A G E N D A

Architectural Review Board

September 26, 2017

1203 South Perry Street

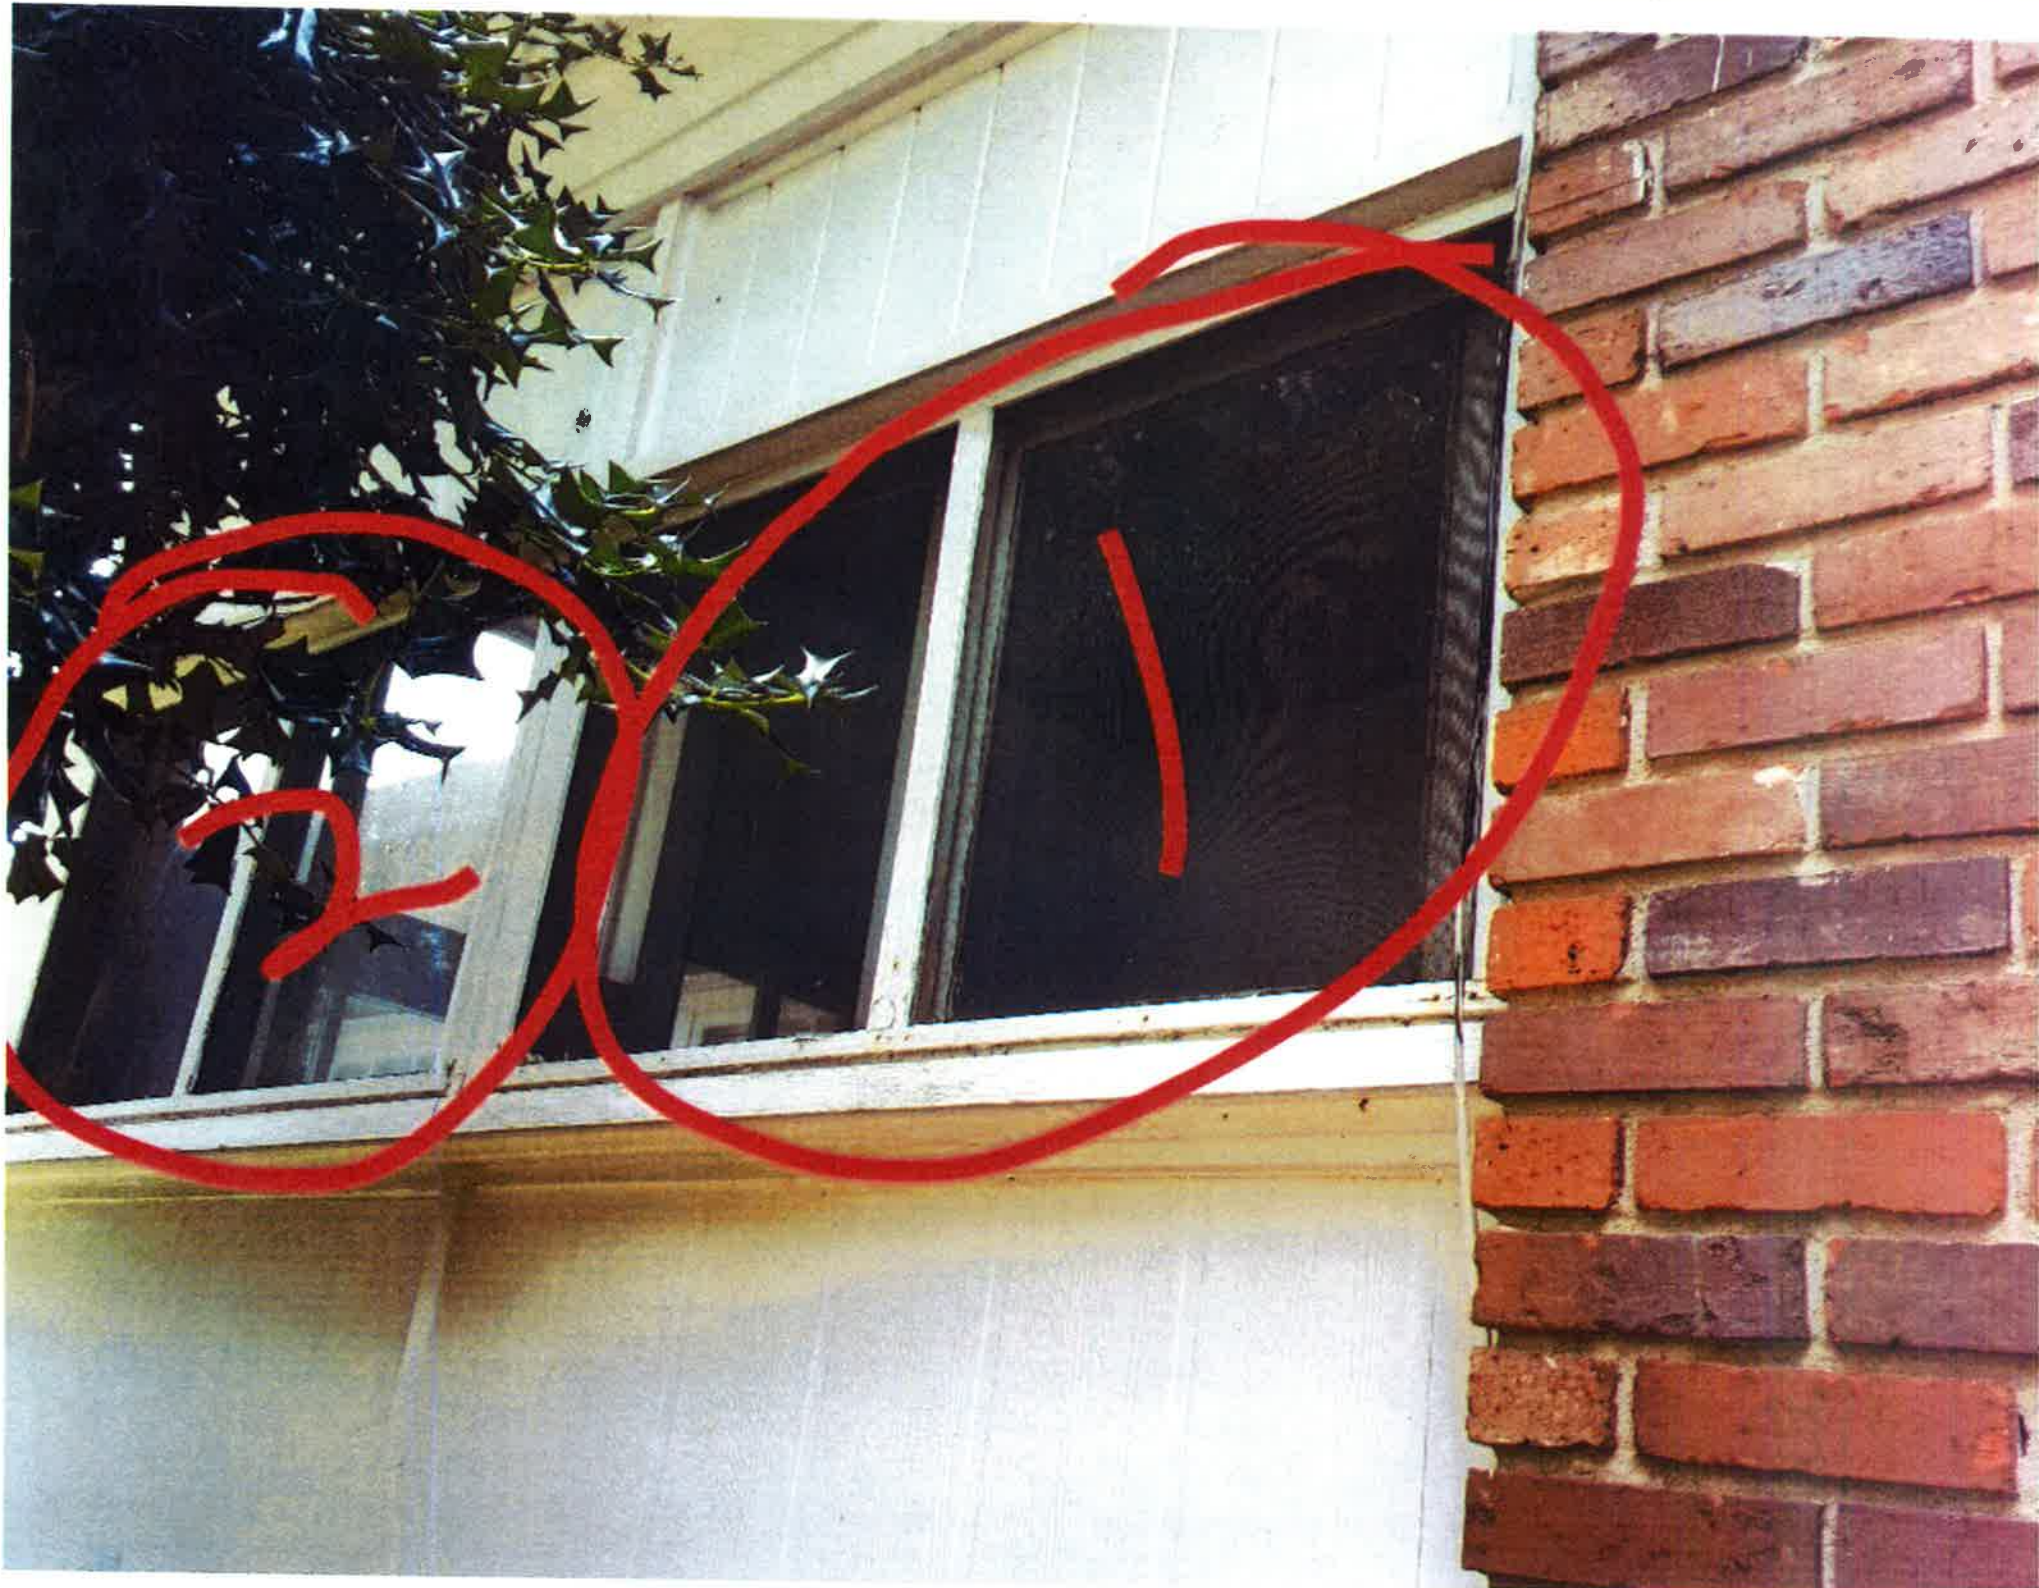
- This window is one the Board has not seen before. The windows to be replaced appear to be in what was likely a porch that was enclosed some time ago, and the windows do not match the other windows in the house.

2004 Madison Avenue

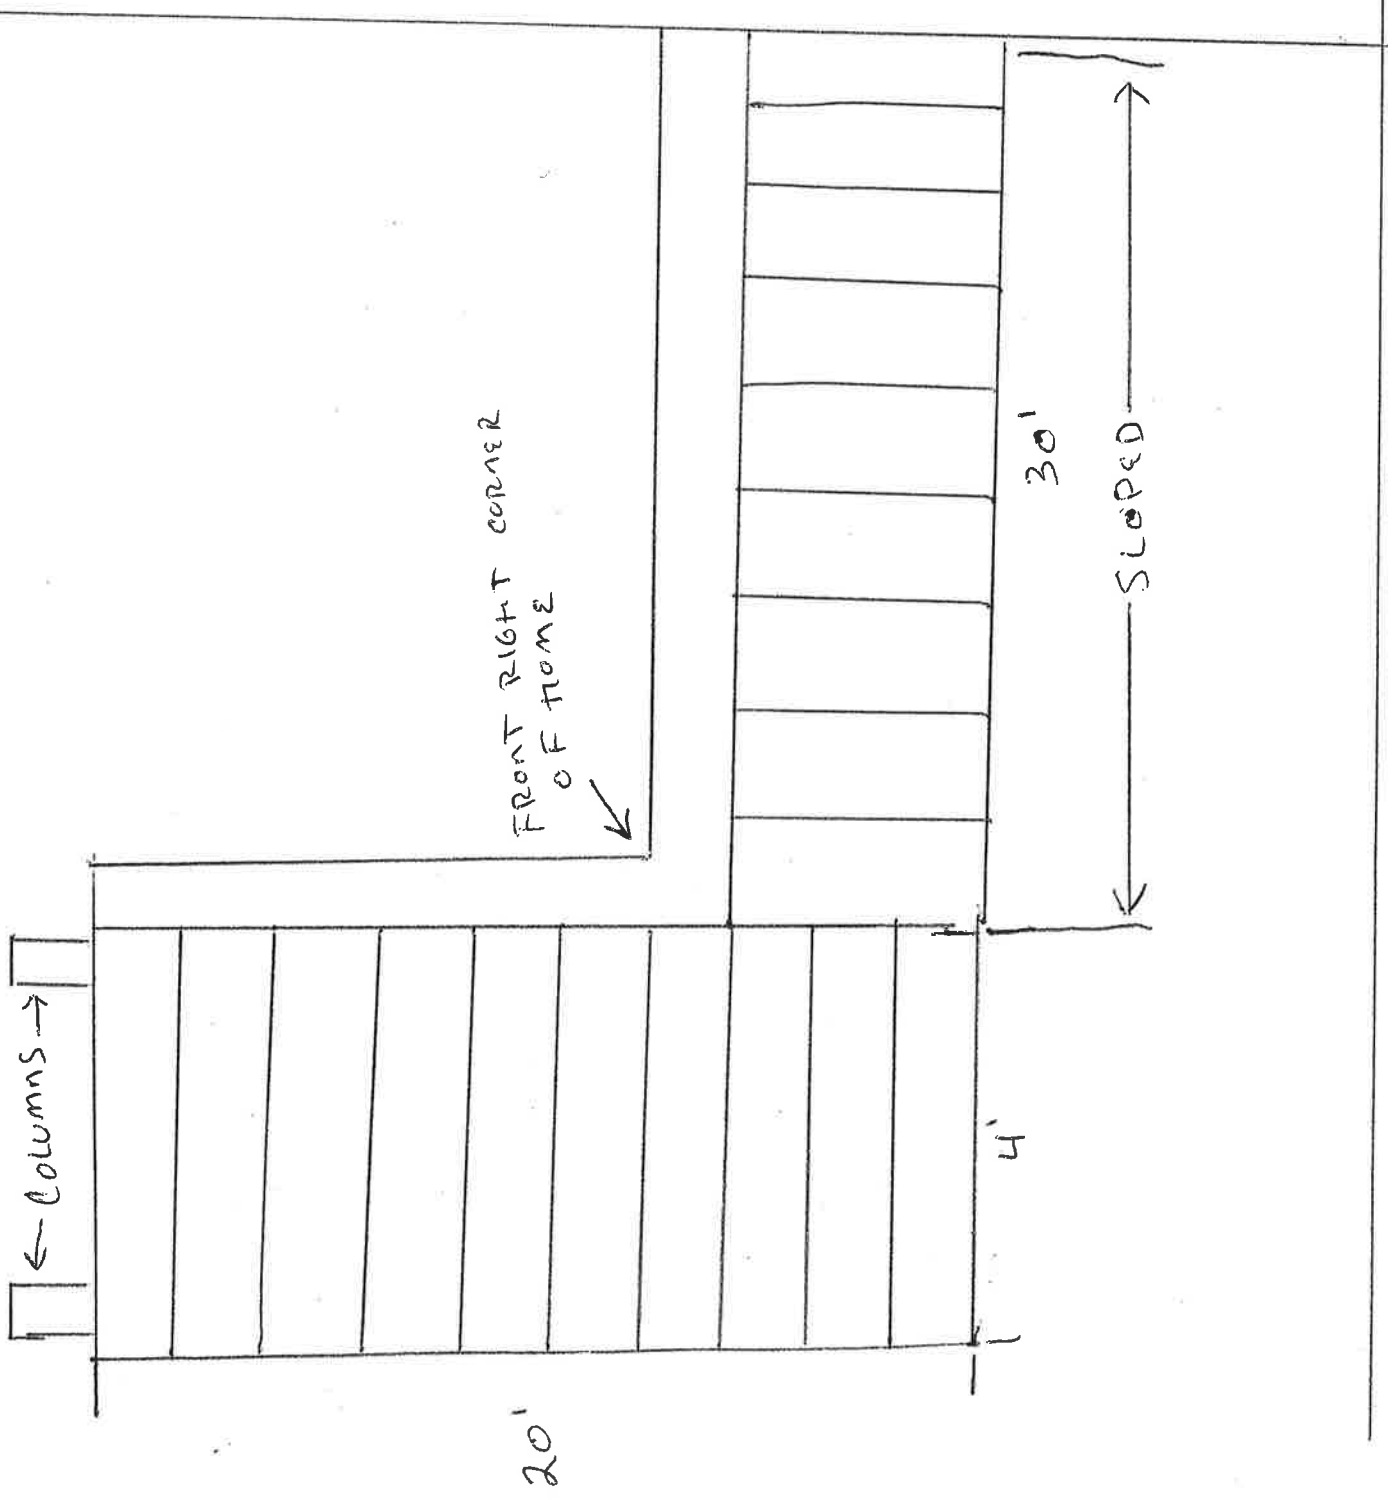
- As I mentioned at the August meeting, we don't review playsets because they tend to be temporary (kids grown up, play sets go away). Handicap ramps for residential structures also meet a particular need at a particular time (versus accessibility issues for commercial/public buildings which tend to be more "permanent" solutions) that sometimes occurs suddenly. To that end, after meeting on site to look at how to construct a ramp that would be inconspicuous and function as needed, staff has given the petitioner permission to install the ramp prior to the meeting if accessibility to the house becomes an insurmountable issue for the owner.

FIRST FLOOR PLAN 1/8" = 1'-0"
 (REV. 8-8-17)
 (REV. 8-25-17)

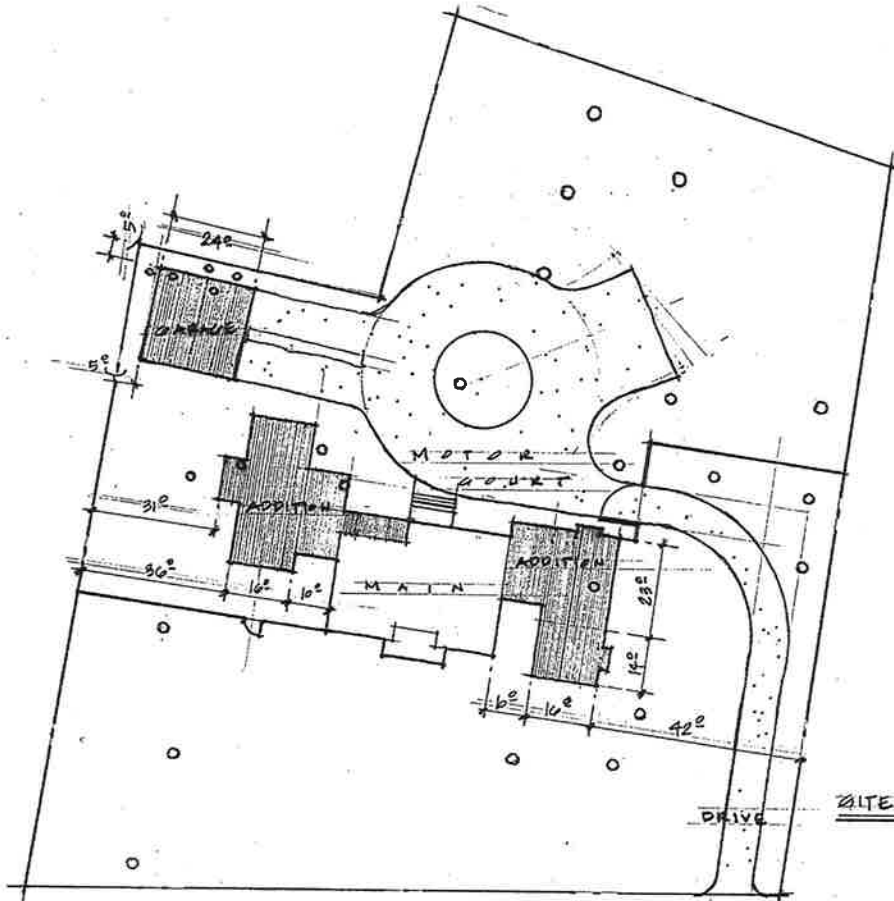
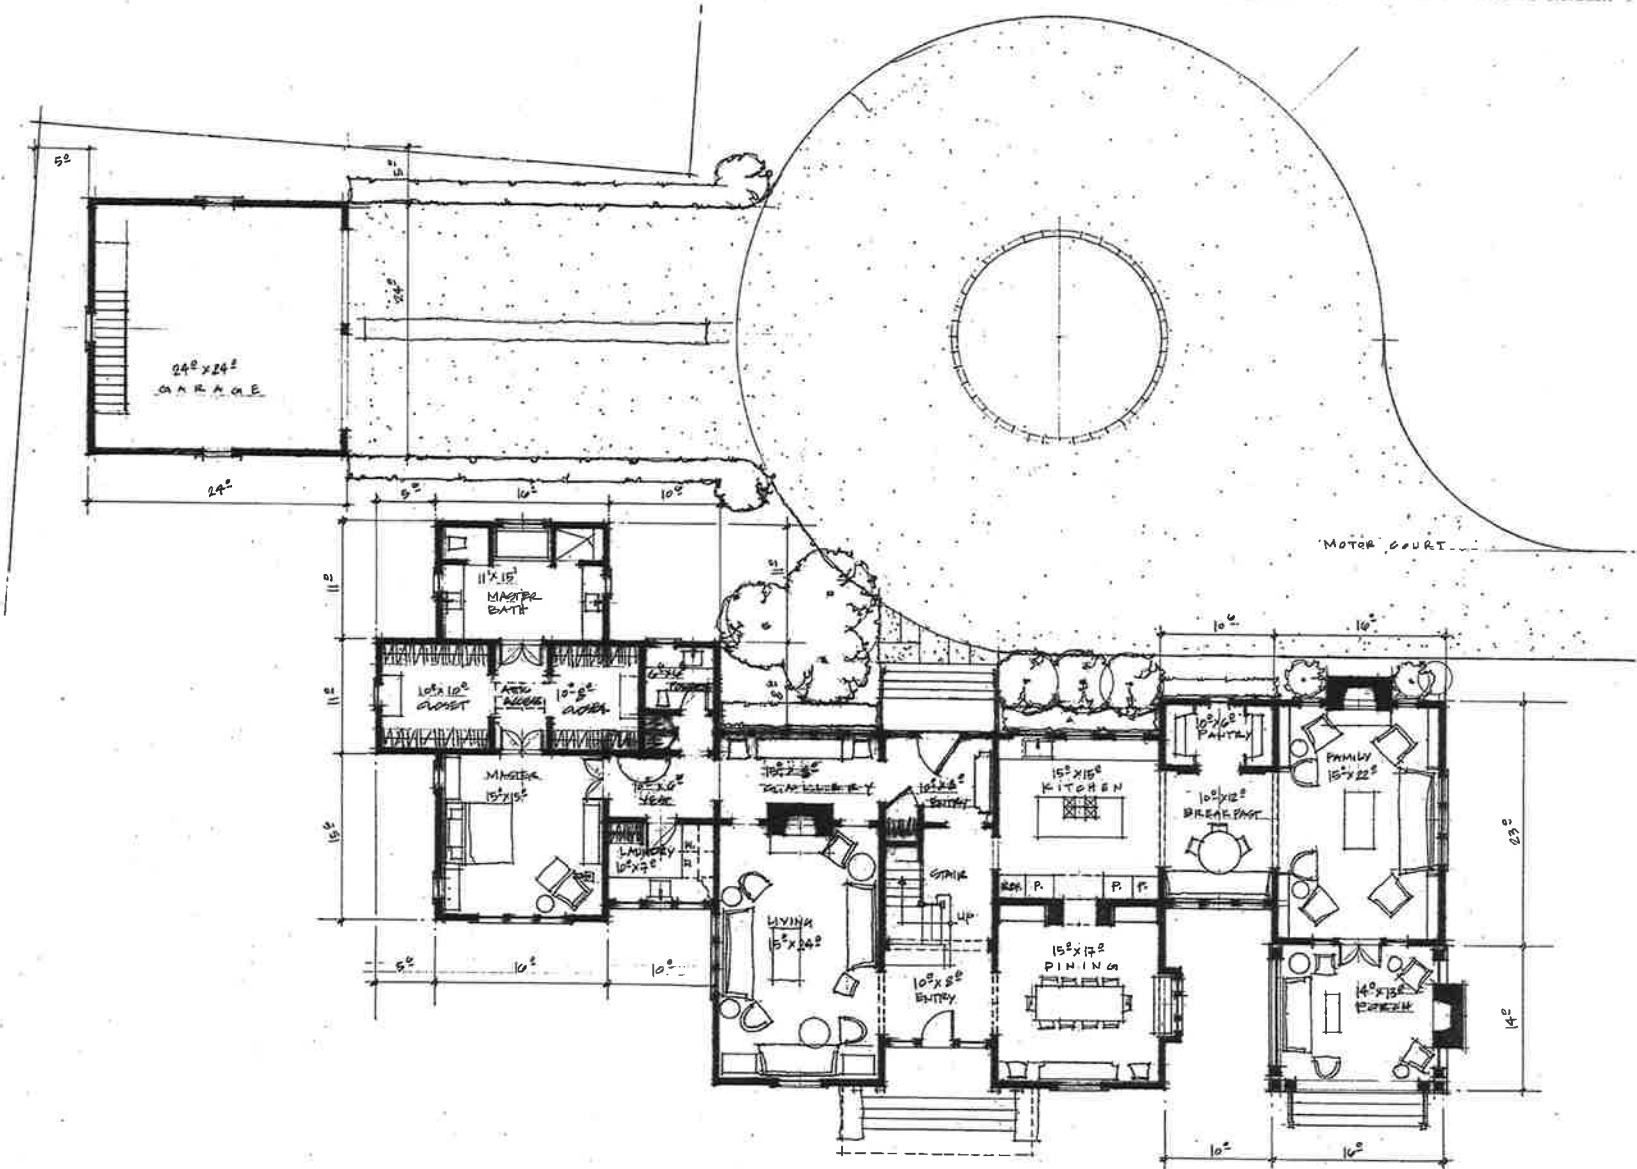
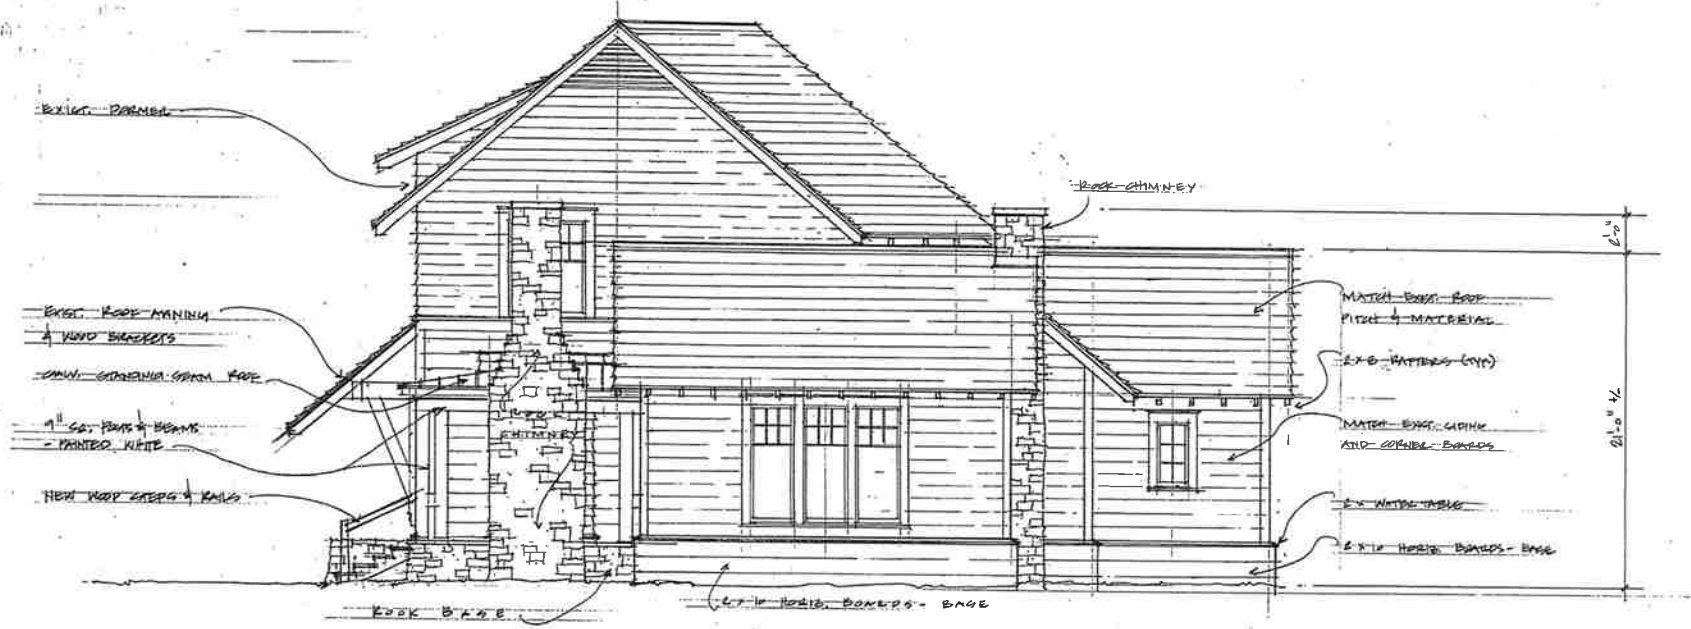
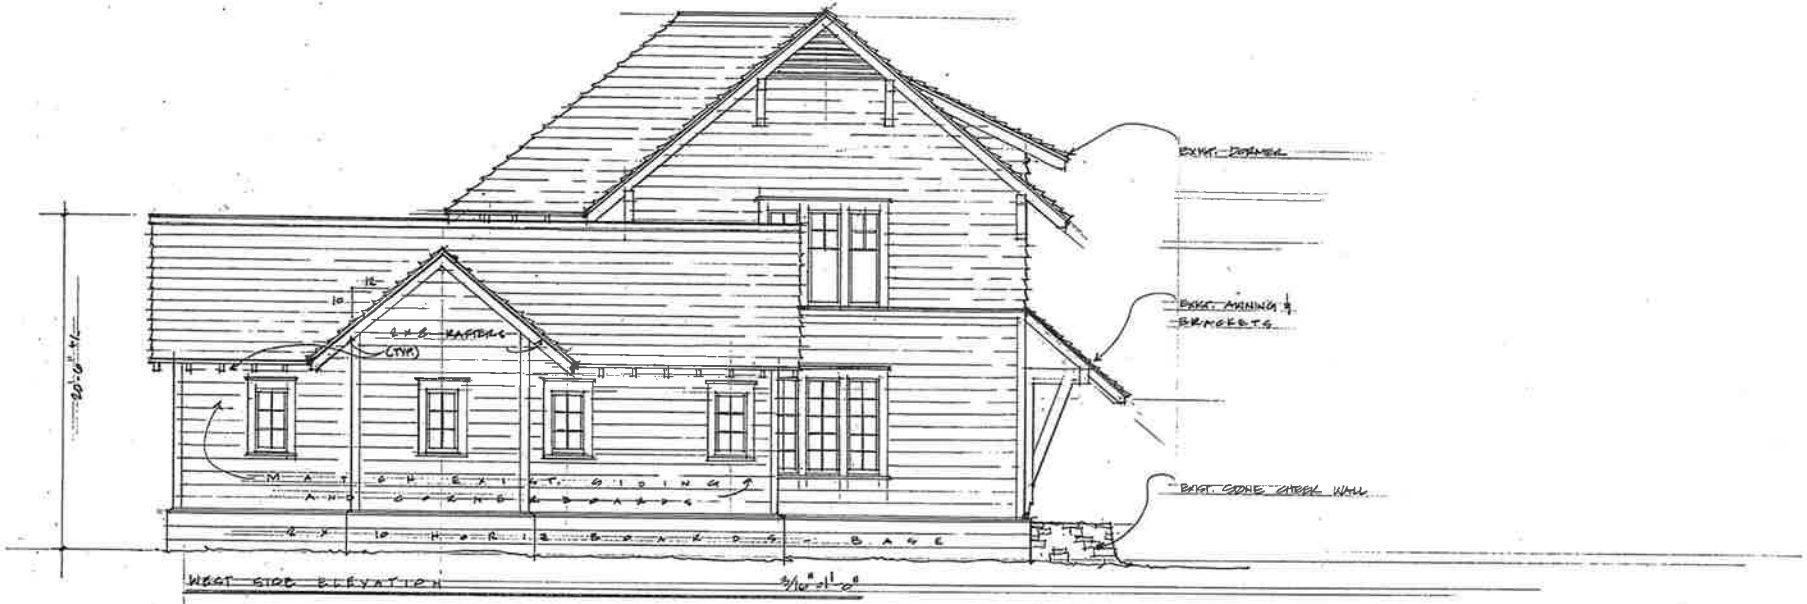
- The Board needs to determine if the scale, placement and design are appropriate for the house. Additions should not overwhelm the historic structure, and should appear secondary to it.
- The house is situated on an unusually large (and unusually shaped) lot on this street.
- Full sized plans will be available at the meeting
